Bulletin #7 of 2025. November 4, 2025

⚠ SAFETY BULLETIN

455 Balanced Regulator P/N 505-455: Required Attention

Products Affected: P/N 505-455 455 Balanced Regulator.

The location of the P/N 220-056 bearing clip is shown above.

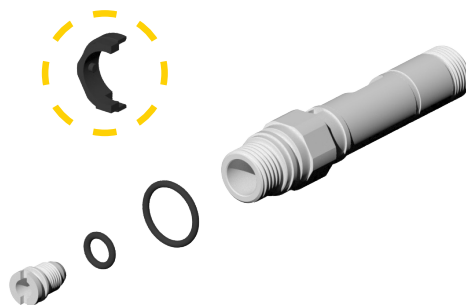
There have been two recent reports of the 455 Balanced Regulator P/N 505-455 failing to supply air on demand at depth, causing divers to switch to steady flow and abort the dive; one was in a training environment and the other in the field. In both cases, when the demand regulator cover was removed, the plastic bearing clip P/N 220-056 was broken. Additionally, through industry communication, we have been informed of broken bearing clips that did not impact the demand regulator's performance.

Testing at Dive Lab has determined that the most likely cause of the clip failure is an excessive gap in the lever arm feet. This excessive gap could result from the lever bending during maintenance. The updated Kirby Morgan service module and Dive Lab technical training courses now stress the importance of maintaining the correct lever arm feet gap and include the revised, standard installation procedure.

If the lever arm's feet gap is too wide, it can exert pressure on the bearing clip and, over time, cause excessive wear. This wear may allow the lever arm's feet to expand enough to detach from the inlet valve. Extensive testing at Dive Lab with the bearing clip removed and the lever arm's feet set to the "proper gap" showed no performance loss or regulator failure. However, testing with the clip removed and the lever arm's leg gap larger than the acceptable range indicated that the inlet valve engagement could be lost.

Immediate Action Required: All users should check their 455 Balanced Regulator following the recommendations in this safety bulletin and the new technical guidance provided by Kirby Morgan in the 455 Balanced Regulator (455BAL) module, available under Support > Manuals and BlowAparts.

Action Taken: Kirby Morgan has revised the reassembly procedure for the 455 Balanced Regulator to emphasize the importance of the correct lever arm's feet gap and to include detailed instructions on reassembly and the significance of the lever arm's feet gap. Additionally, the technician training course will follow the modular manual instructions. Kirby Morgan is also creating an online step-by-step video to supplement the 455 Balance Regulator manual module. Dive Lab continues to conduct trials on the 455 Balanced Regulator in their lab, service center, and classroom, providing daily updates on their findings. Over 400 function tests on both correct and incorrect reassembly of the main tubes have been
